REGULATORY INFORMATION DISTRIBUTION SYSTEM (RIDS)

SUBJECT: Clarifies 880212 response to violation noted in Insp Rept 50-400/87-38.

SHEARON HARRIS NUCLEAR POWER PLANT
DOCKET NO. 50-400
LICENSE NO. NPF-63

SHEET 4

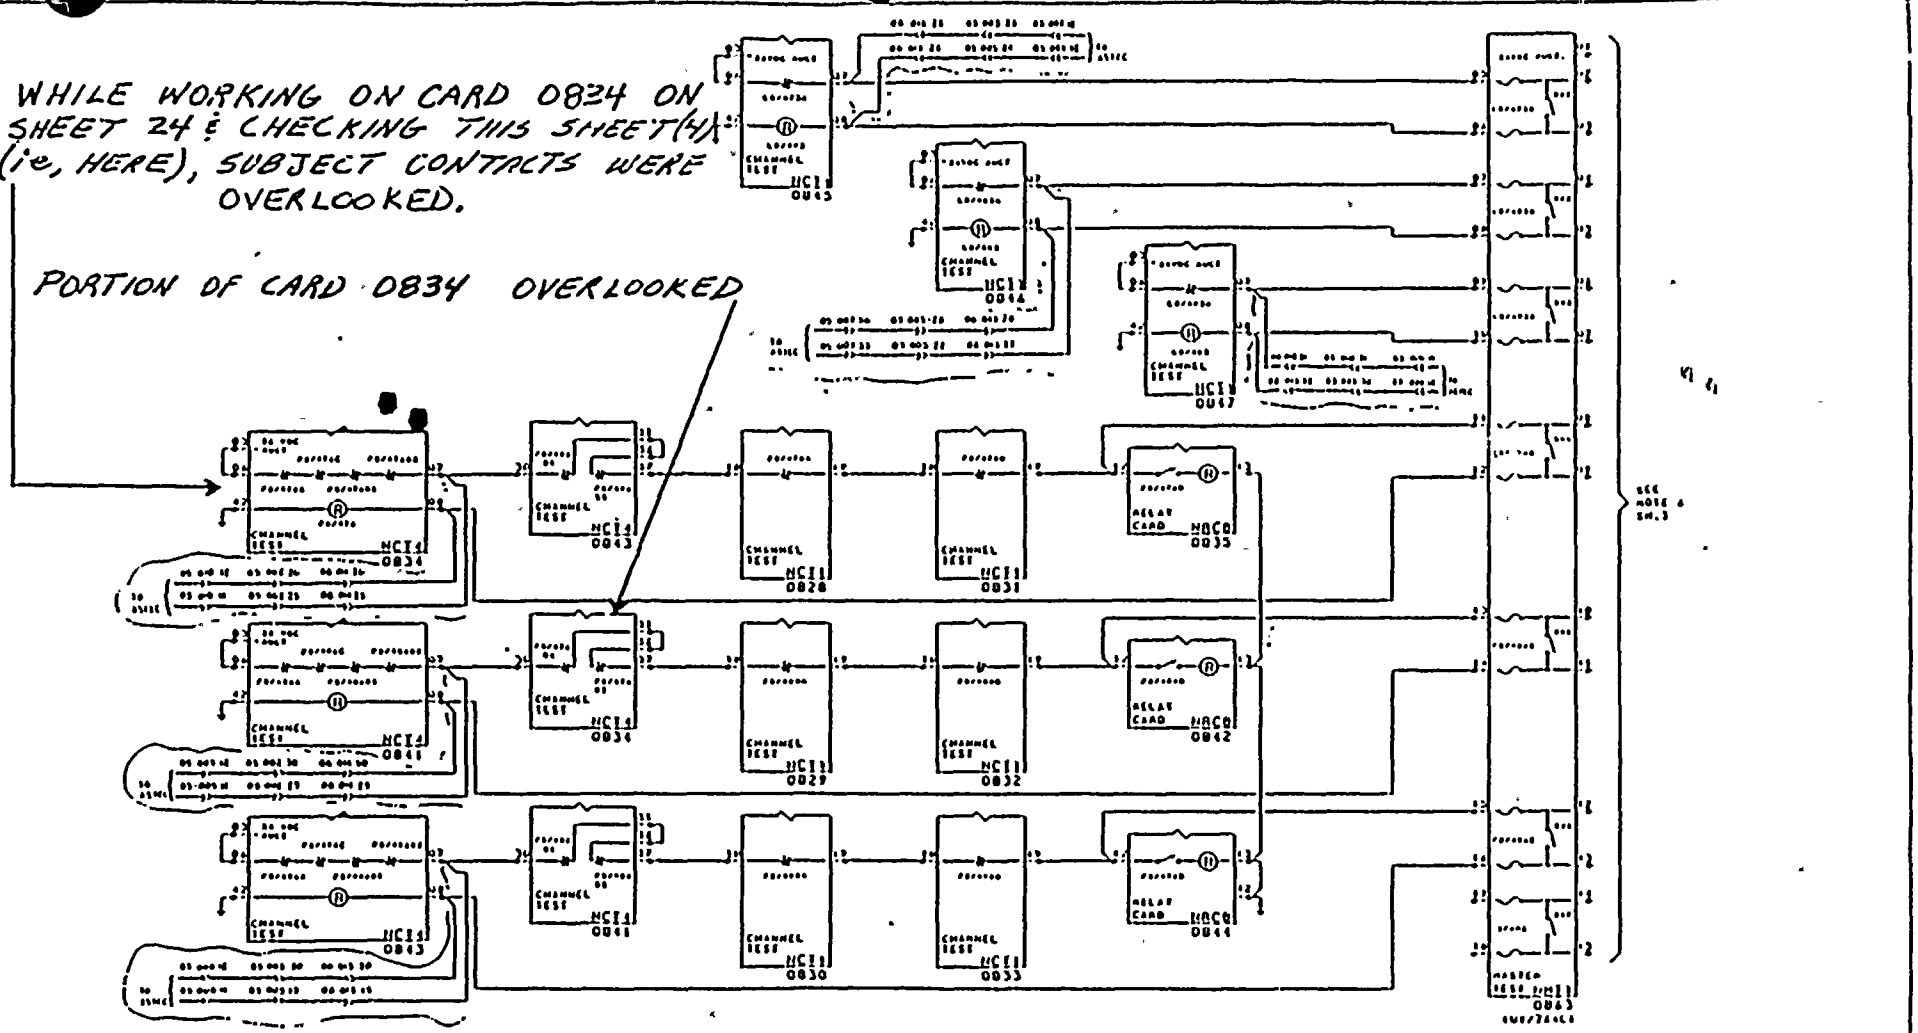
Your letter indicates a misunderstanding of our response in regard to the circuit boards being shown in two locations on one of the two schematics involved. Portions of the boards were shown in three locations, one on sheet 24 and two locations on sheet 4. Both schematics were used as design inputs, however, the design engineer working the modification (PCR-2292) inadvertently overlooked the second portion of the board shown on sheet 4 (Schematics attached). This caused the use of unavailable contacts in the design.

WHILE WORKING ON CARD 0824 ON SHEET 24 & CHECKING THIS SHEET(4) (ie, HERE), SUBJECT CONTACTS WERE OVERLOOKED.

PORTION OF CARD 0834 OVERLOOKED
